JERSEY CENTRAL POWER & LIGHT COMPANY
OYSTER CREEK NUCLEAR GENERATING STATION

Technical Specification
Change Request No. 98
Docket No. 50-219

Applicant submits, by this Technical Specification Change Request No. 98 to the Oyster Creek Nuclear Generating Station Technical Specifications, a change to Specifications Sections 2.2, and 2.3.

SAFETY EVALUATION FOR THE
INCREASE IN THE OYSTER CREEK
RELIEF VALVE SET POINTS

FIGURE 1a

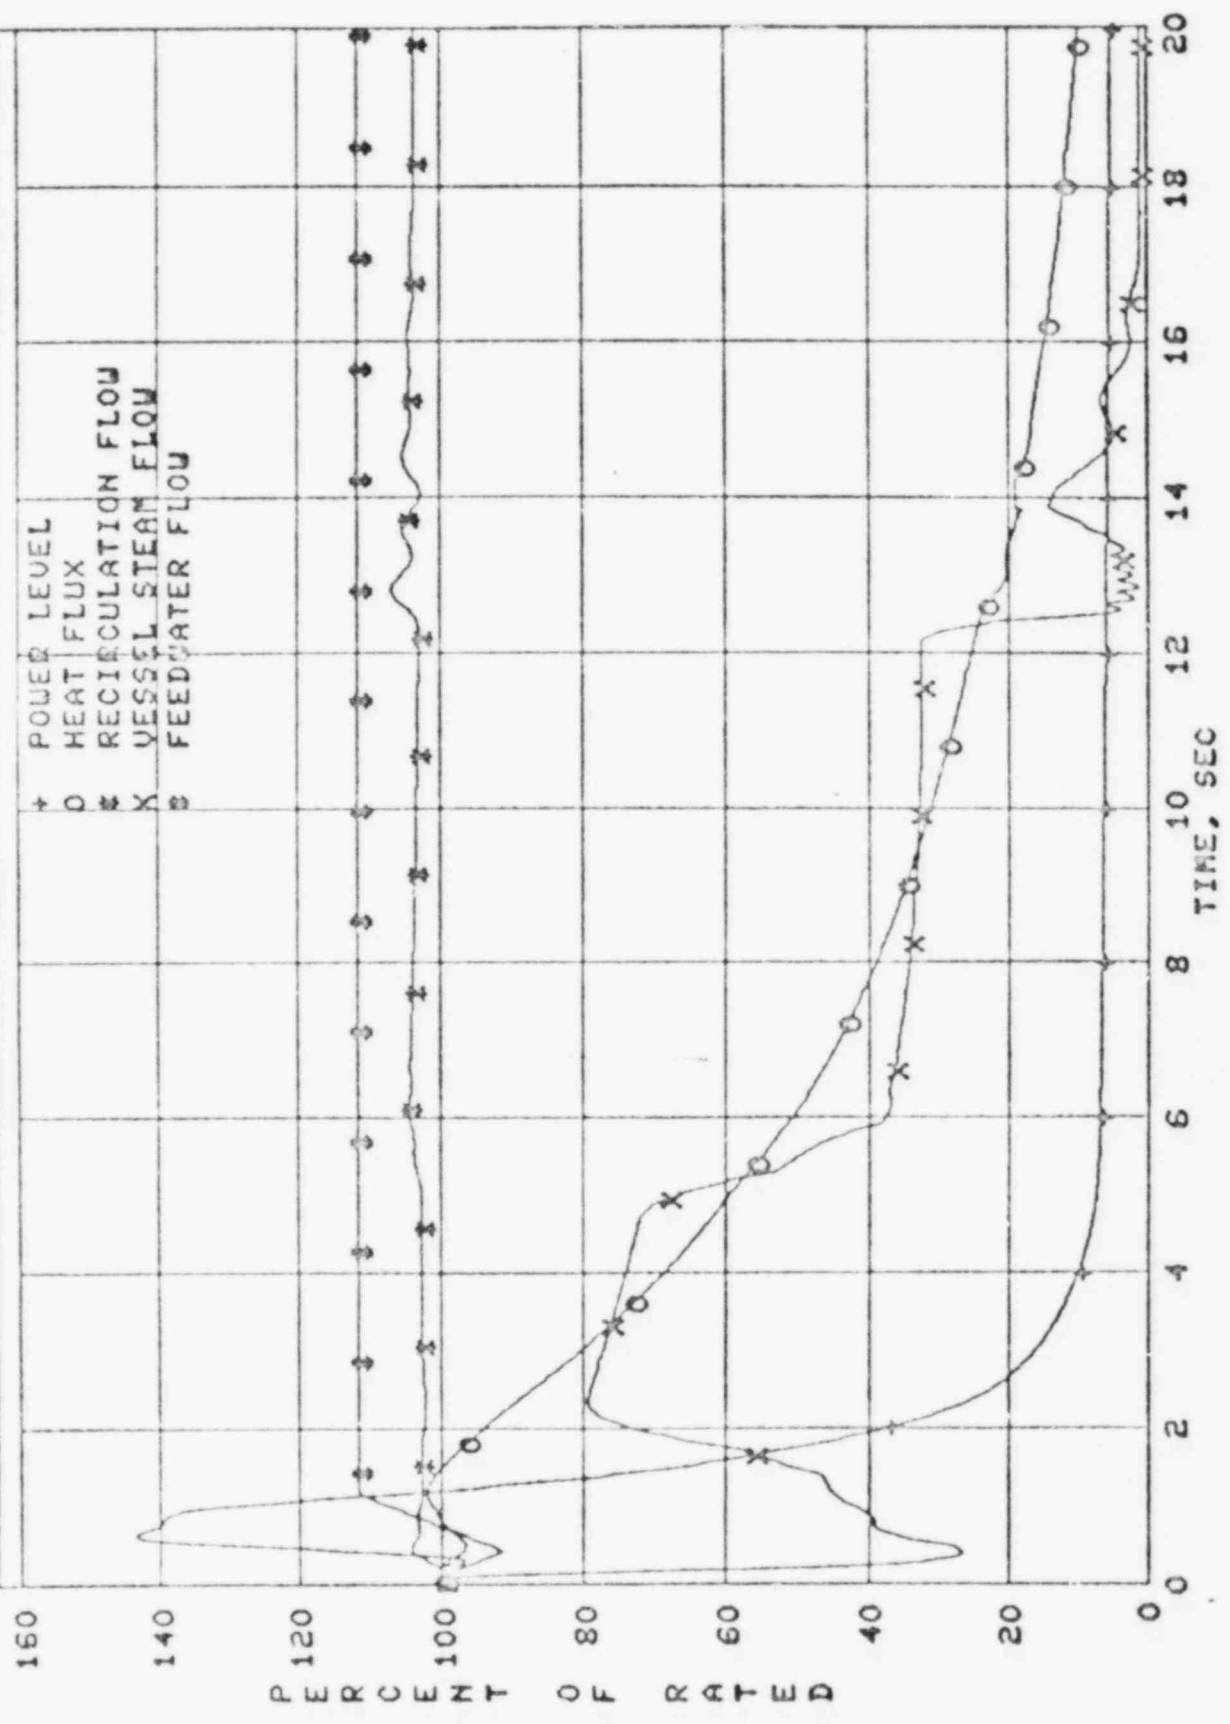
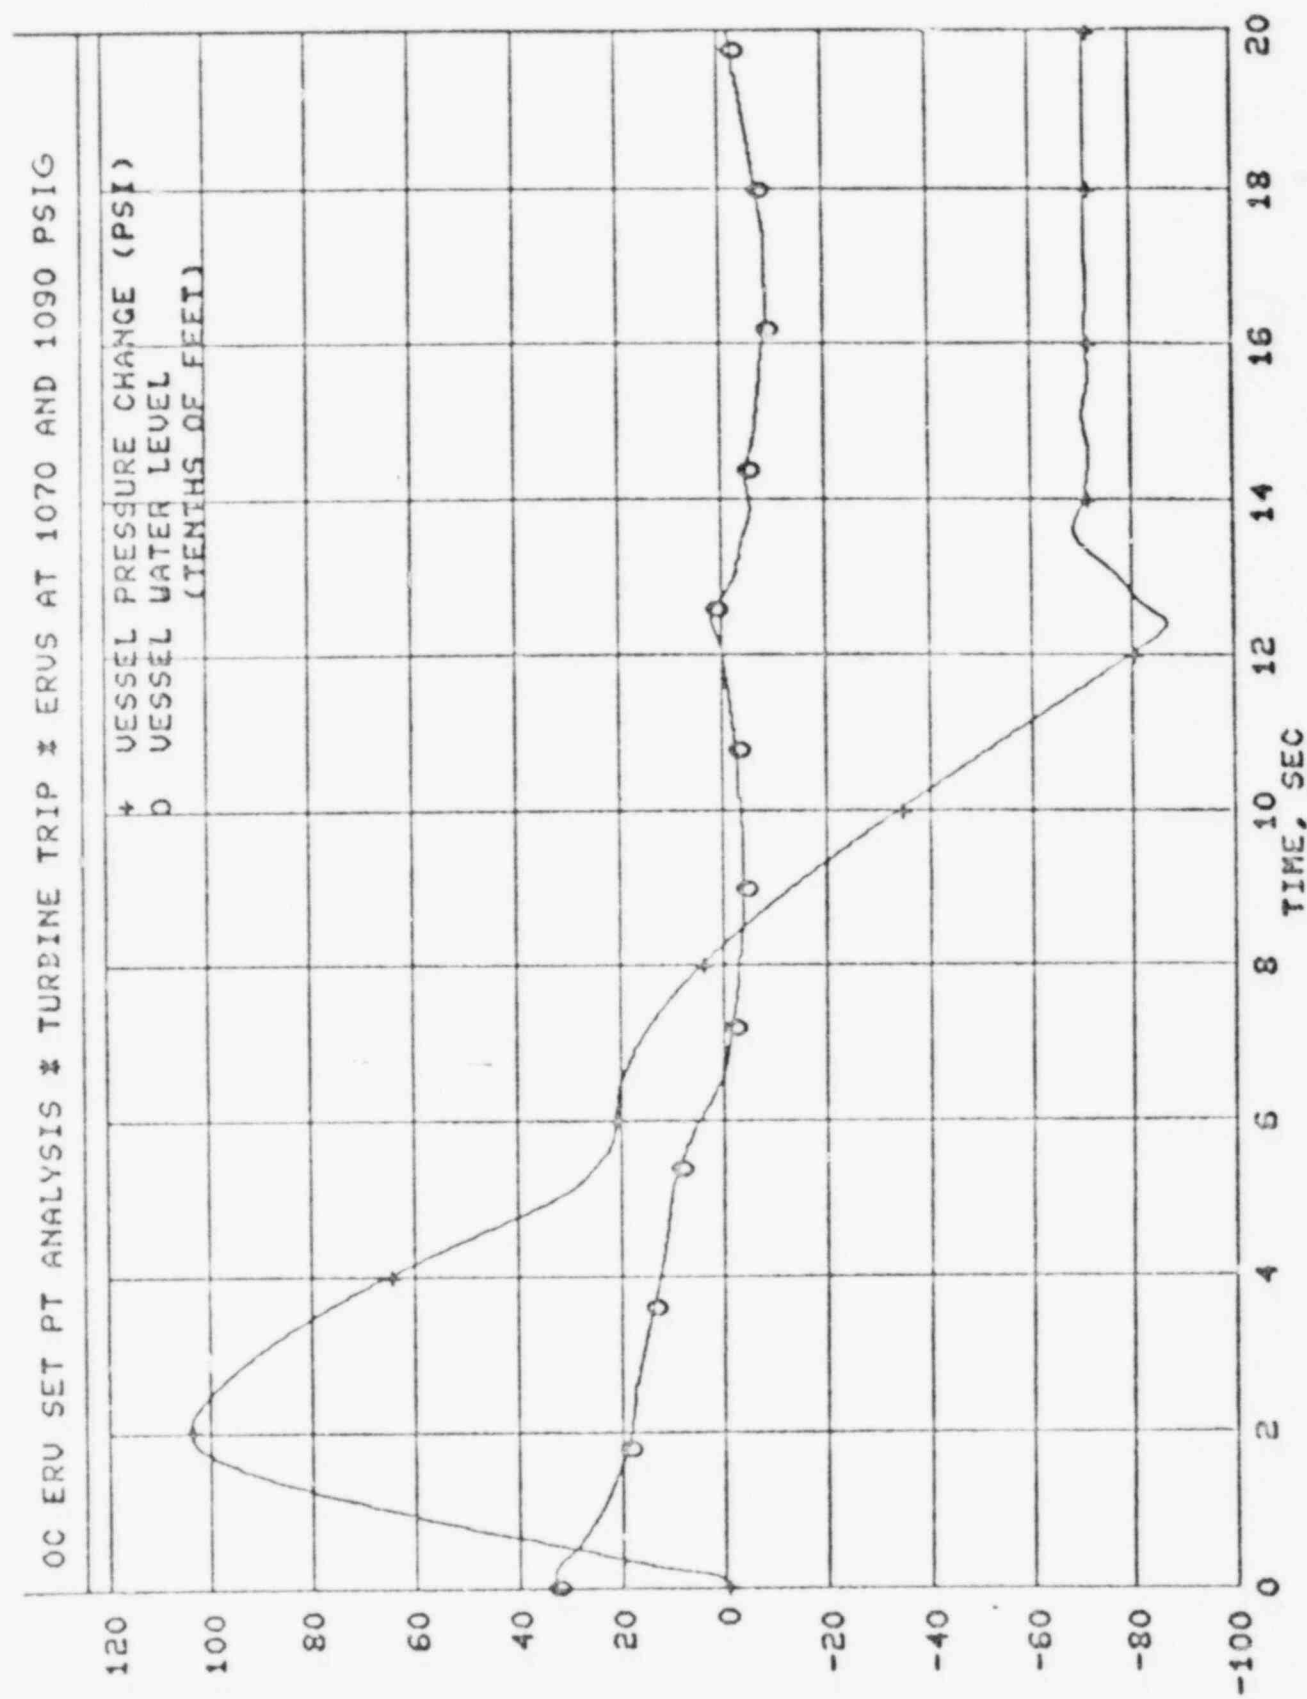
A turbine trip is the primary turbine protection mechanism and is initiated whenever various turbine or reactor system malfunctions threaten turbine operation. The turbine trip initiates closure of the turbine stop valves and opens the bypass valves. Upon initiation of the trip, pressure rises, opening the first two ERV's at 1.4 seconds. All 5 ERV's are open by 2.0 seconds and are closed by 6.0 seconds. A peak pressure of 1129.3 psia occurs at 2.0 seconds which is well below the SV set points. The transient response is shown in Figures 1a and 1b.

FIGURE 2a

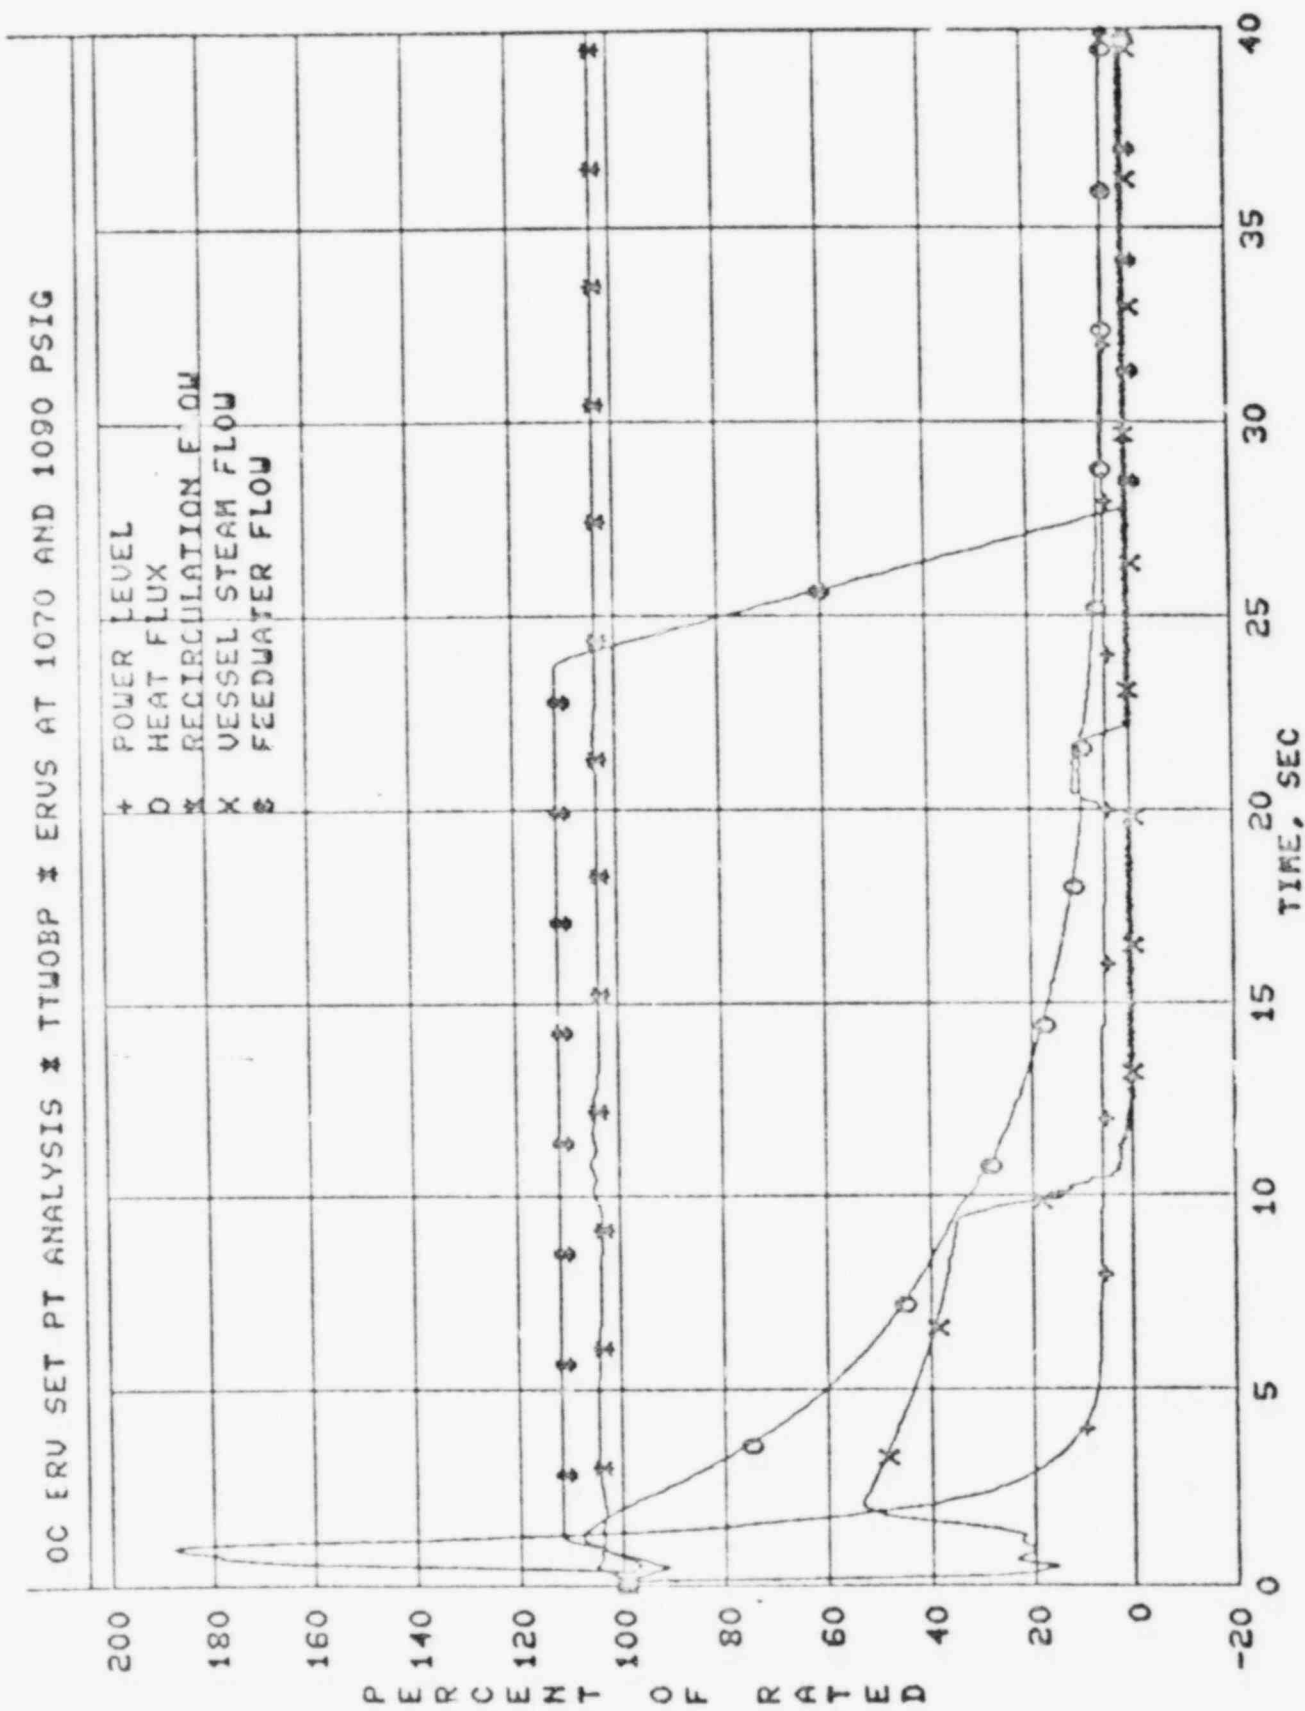
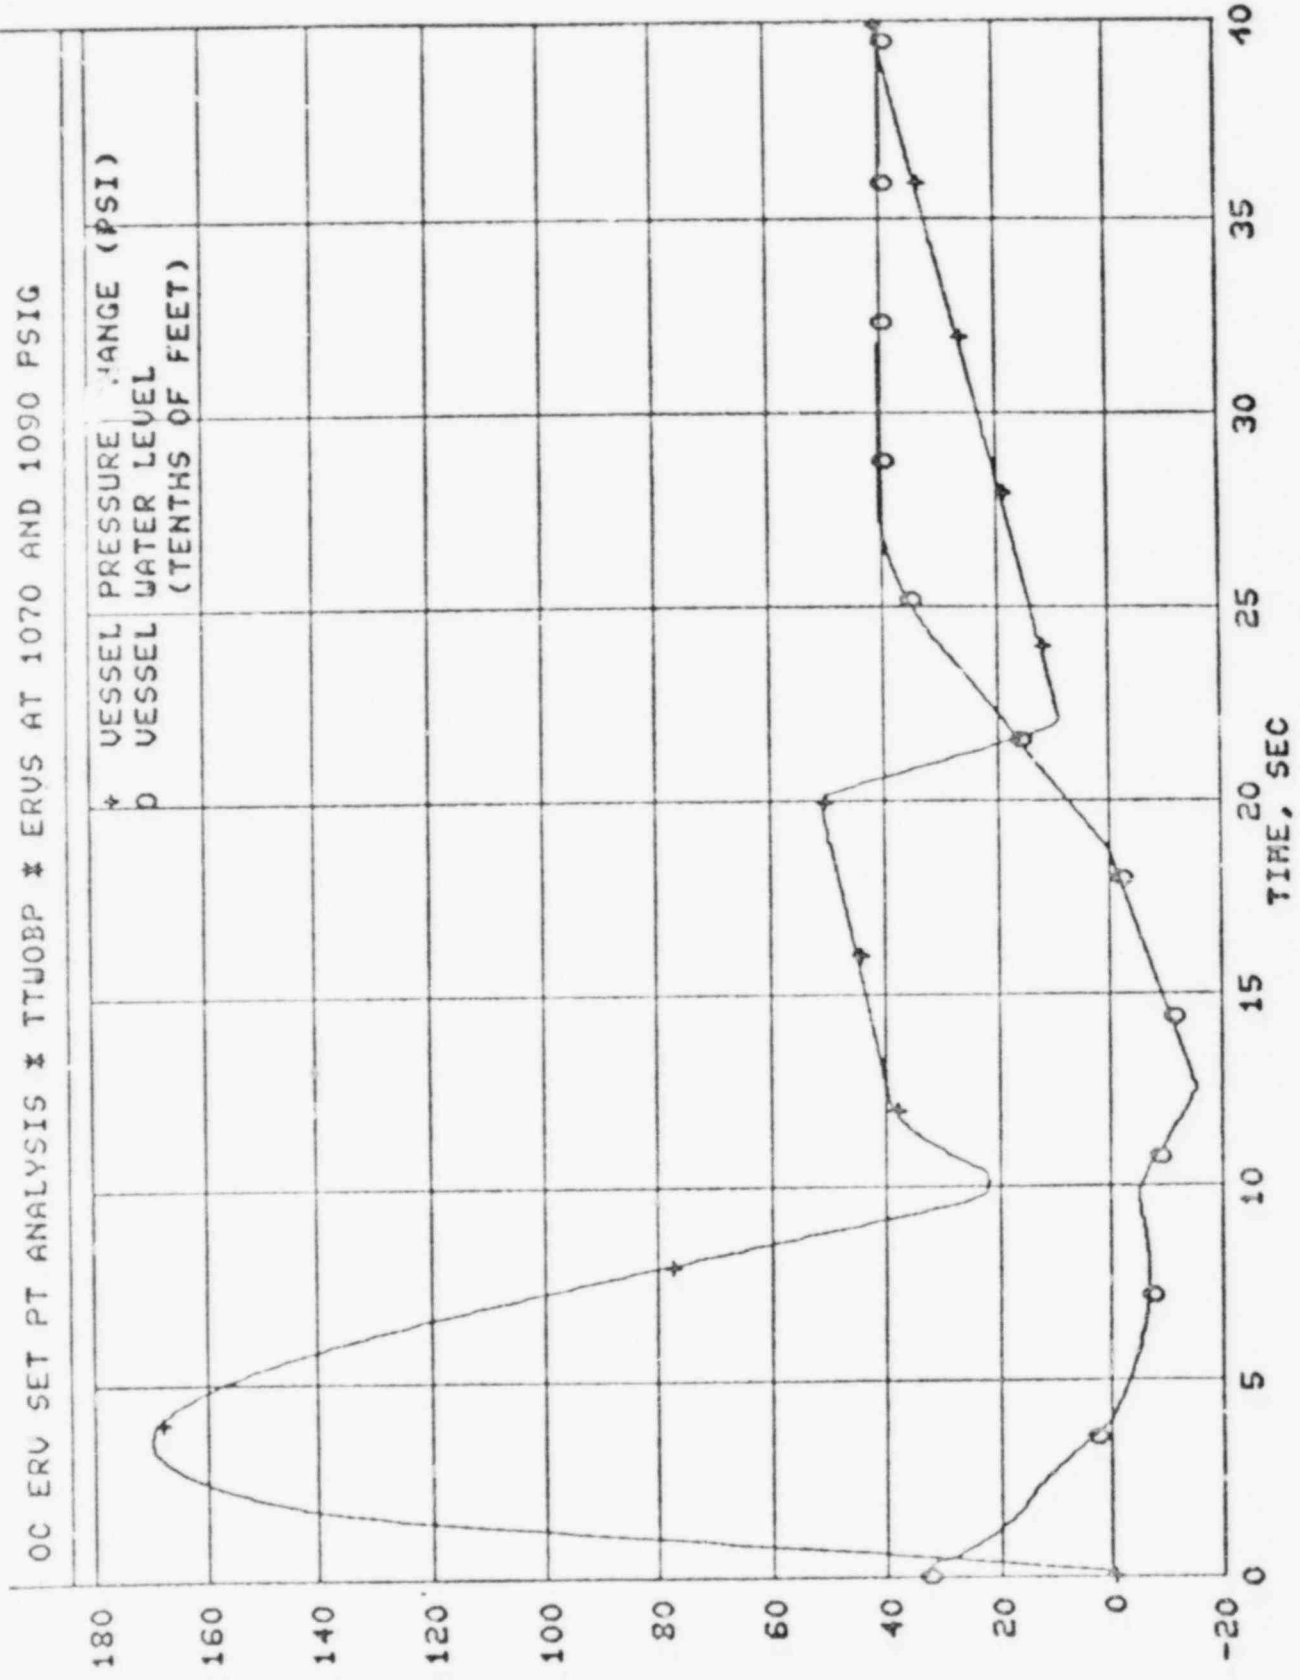
The relief-valve sizing transient (TTWOBP) demonstrates the adequacy of the relief valves in keeping pressure below the safety valves set points. The failure of the bypass valves to open following a turbine trip results in a rapid pressurization, opening the first two relief valves at 1.2

seconds and all five valves by 1.5 seconds. The valves are all closed at 10.5 seconds. A peak pressure of 1201 psia is reached at 3.6 seconds, 26 psi below the lowest safety valve lift set point. Pressure in the dome reaches 1204.9 psia and 1215.3 at the core midplane, which is below design limits. The isolation condenser is actuated at 1065 psia; this does not affect peak pressure, but assures that the system will not re-pressurize following closure of the relief valves. The transient response is shown in Figures 2a and 2b.
